CITY PLANNING COMMISSION  
1231 "I" STREET, SUITE 200, SACRAMENTO, CA 95814

APPLICANT: Hallenbeck, Chamorro & Associates, 2415 Mariner Square Dr., Alameda, CA 94501  
OWNER: United Services Automobile Association, USAA Building, San Antonio, Texas 78288  
PLANS BY: Hallenbeck, Chamorro & Associates, 2415 Mariner Square Dr., Alameda, CA 94501  
FILING DATE: November 24, 1992 ENVIR DET - Neg. Dec REPORT BY: Doug Holmen  
ASSESSOR'S PCL. NO. 277-0151-15, 26

- APPLICATION:
- A. Mitigation Monitoring Plan
  - B. Special Permit Modification to construct a total of 702,394± square feet of office, including an existing 288,611± square feet of office on 23.05± partially developed acres in the Office Building (Planned Unit Development) (OB{PUD}) and Light Industrial (M-1) zones.
  - C. PUD Schematic Plan Amendment to rearrange the construction of pre-approved 413,833± square feet of office and related uses in the OB(PUD) and M-1 zones.

LOCATION: Northwest corner of Arden Way and Harvard Street (2241 Harvard Street).

**SCHEMATIC SITE PLAN**

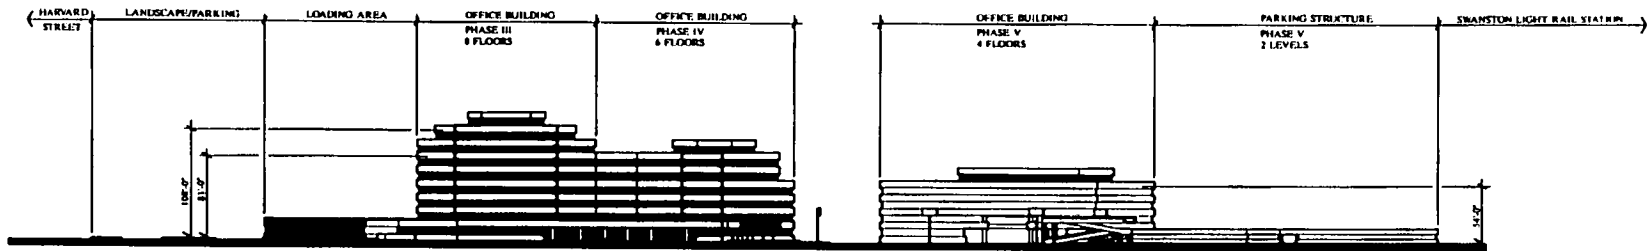
The site plan (Exhibit A) indicates that there would be a total of 2,600 parking spaces associated with the

proposed project. The applicant, however, has indicated in a letter dated March 3, 1993 that the total number of parking spaces would not exceed 2,453 as originally indicated in the previously approved projects (P84-101, P85-018, P87-109). There are currently 1,055 parking spaces in the existing five level parking structure off of Silica Avenue. The applicant proposes to construct a 5 level parking structure adjacent to the existing parking structure which would contain 649 spaces for Phase III and an additional 494 spaces in Phase IV for a total of 1,143 spaces. Phase V would contain a two level parking structure at the southwest corner of the site which would contain 402 spaces. Currently, there is visitor parking off of Harvard Street adjacent to the existing most southerly building. The applicant proposes to construct an additional 20 visitor parking spaces adjacent to the Phase V building when Phase V is built (see parking table on Exhibit A). The additional 147 spaces (2,600 minus 2,453) would need to be removed from one of, or in combination of the Phase III, IV and V projects.

ELEVATIONS

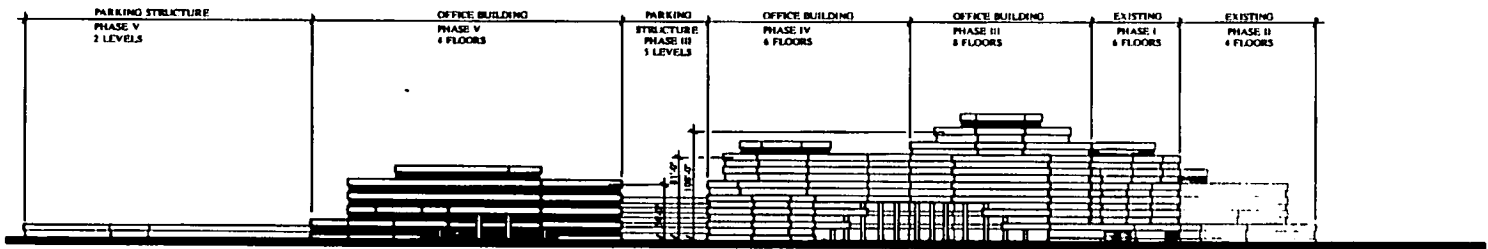
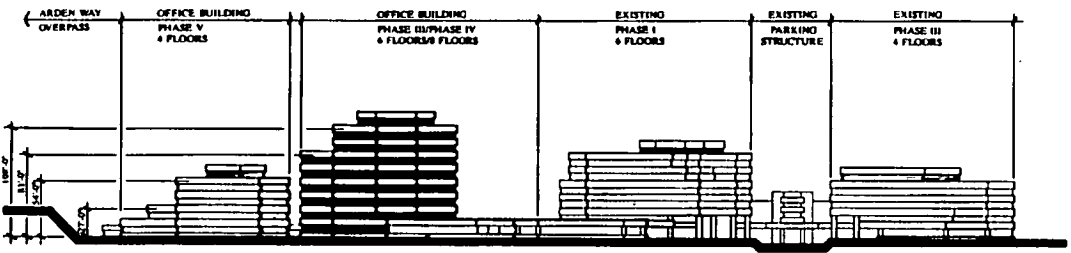
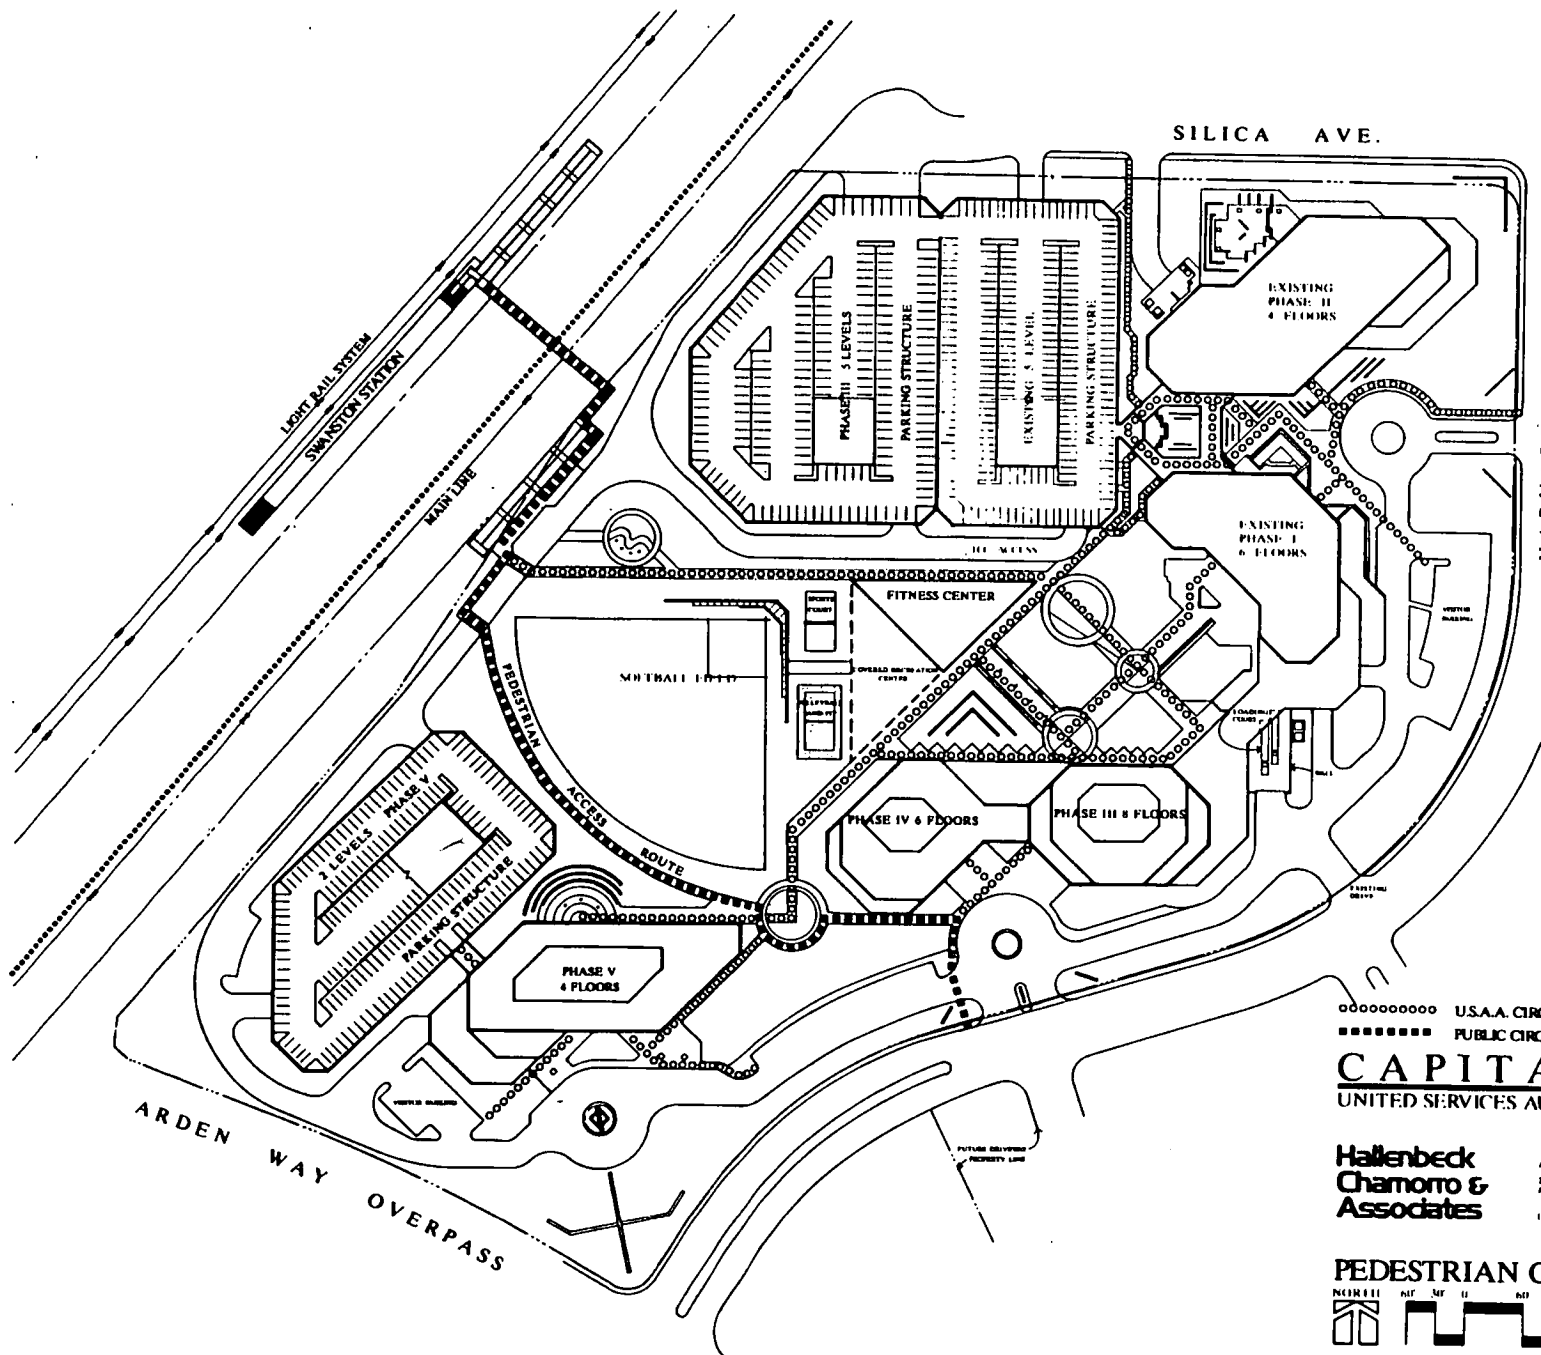
The proposed project has less height than the originally approved project. It would be no more than eight stories high (126 feet) for its highest building rather than 148 feet as was previously planned. The proposed project would be rearranged from a linear campus configuration to a style which would have the heights ascending from the north, south, and west to the eastern portion of the site where the highest building would be the eight story phase III building adjacent to Harvard Street near the middle of the site which would be across the street from the California Plaza I and II office structures. Staff prefers this arrangement. Instead of a jagged skyline, the proposed buildings juxtaposed with the buildings across Harvard Street would be symmetrical with the higher buildings being closer together and the skyline stepping down toward Arden Way, the railroad tracks, and the area to the north across from Silica. The baseball field and other recreation facilities would be in the middle of the of the site surrounded by the office and parking structures on the north, east, and south sides; and the Southern Pacific Railroad trackage on the west side. Also planned is a inner plaza area between the recreation center and the office buildings. A jogging trail is planned to loop around the baseball field and the recreation center as well as be along side of the pedestrian walk which would bisect the site from the light rail pedestrian

The proposed three buildings would match the existing two buildings in design, materials and exterior building colors. They would be precast concrete with grey glazing. The color would be Architectural White. The Phase III building would be eight floors and be approximately 126 feet in height. The Phase IV building would be six floors and be approximately 86 feet in height. The Phase V building would be 4 floors and be approximately 72 feet in height. The proposed fitness center would be one floor and be approximately 21 feet in height. The Phase III and Phase V parking structures would likewise be of the same design as the existing parking structure. The Phase III parking structure would be connected to the existing Phase I parking structure.

**SCHEMATIC LANDSCAPE PLAN**  
 NORTH  
 1" = 20'  
 11/18/92

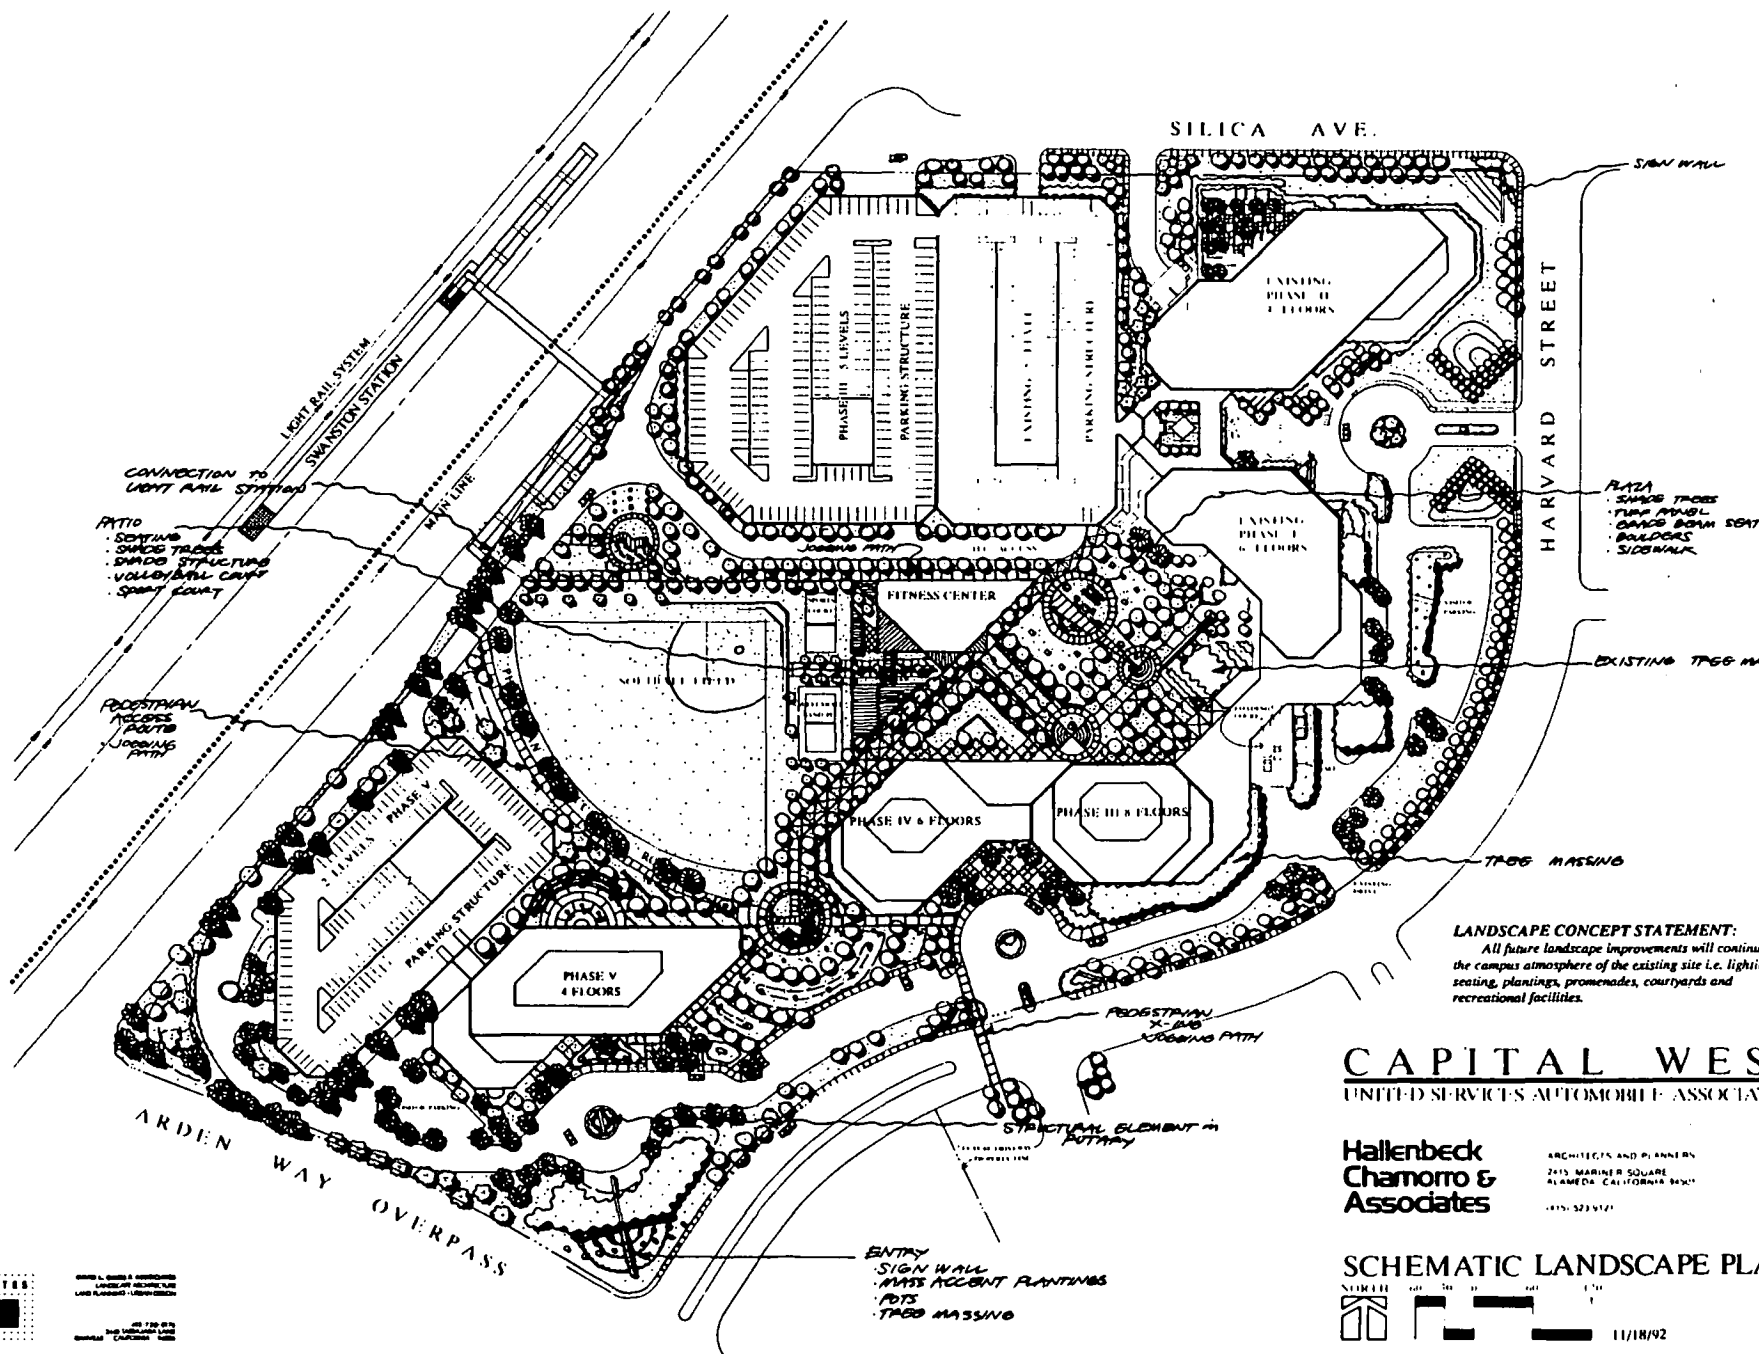
The proposed project would need to follow the original landscape plan which required the applicant to provide a 25 foot landscaped setback along Silica Avenue, Harvard Street and Arden Way. Those setback areas presently exist. The applicant has submitted a schematic landscape plan which would be irrigated by an automatic irrigation system. A detailed landscape plan would need to be approved by the Planning Director prior to the issuance of a building permit.

1. The applicant shall comply with the conditions of the Mitigation Monitoring Plan (Exhibit F).
2. A signage plan will be approved by the Planning Director prior to the issuance of a building permit.
3. A detailed landscape plan showing the location of and types of plants and trees and how they are to be irrigated will be approved by the Planning Director prior to the issuance of a building permit.
4. The pedestrian bridge/ walkway plan and contract for the maintenance and other responsibilities will be finalized between all parties involved prior to issuance of the building permit.
